Indiana Michigan
Power Company
P.O. Box 16631
Columbus, OH 43216

AEP:NRC:0914E

Donald C. Cook Nuclear Plant Units 1 and 2
Docket Nos. 50-315 and 50-316
License Nos. DPR-58 and DPR-74
MODIFICATION OF SUBMITTALS REGARDING CONTROL ROOM VENTILATION

FIGURE 1

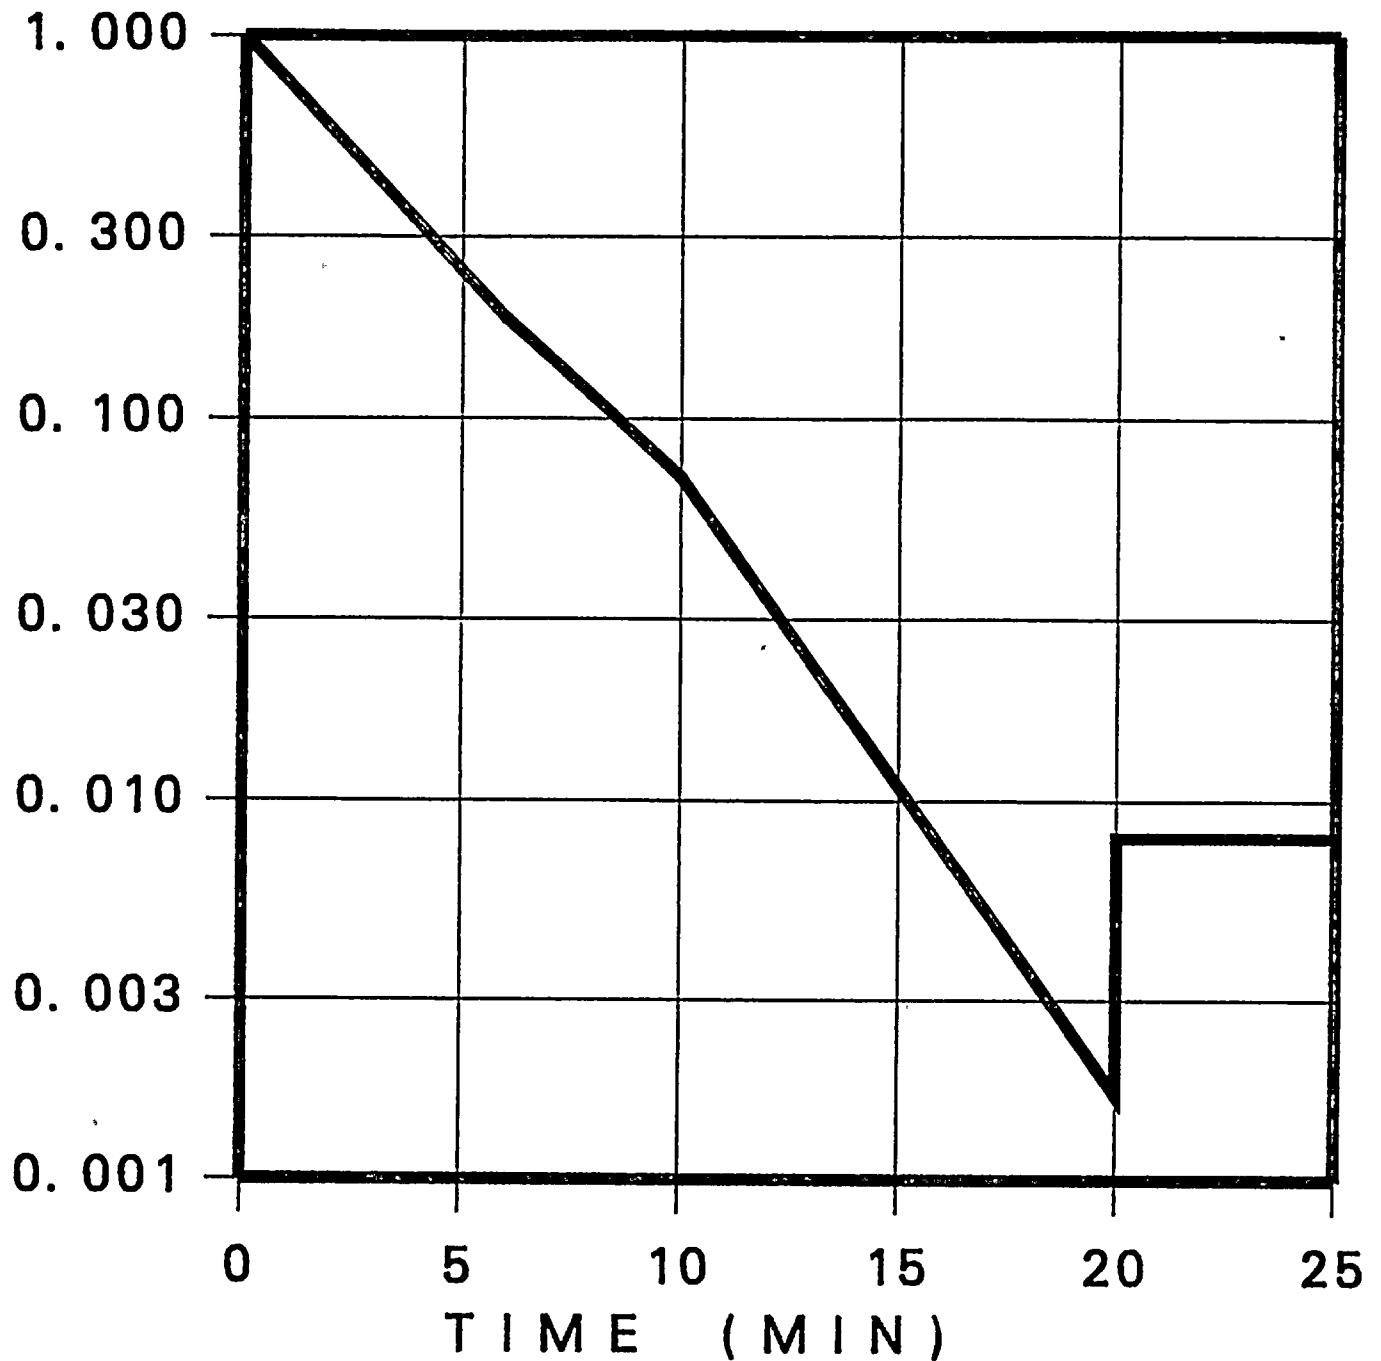
The calculations were revised to correct the error. In the process, several enhancements were made. Elemental iodine

removal was based on a conservative fit to Figure 14.3.5-1 of the Updated FSAR, rather than limited to 10 hr^{-1} as in the original calculation. The specific curve used in our control room reanalysis is provided in Figure 1. The particulate iodine removal coefficient was reduced to one tenth its original value after a DF of 100 was reached; removal continued at the reduced rate until the effect on dose became insignificant. In the original calculation, removal was assumed to stop at the removal rate reset setpoint.
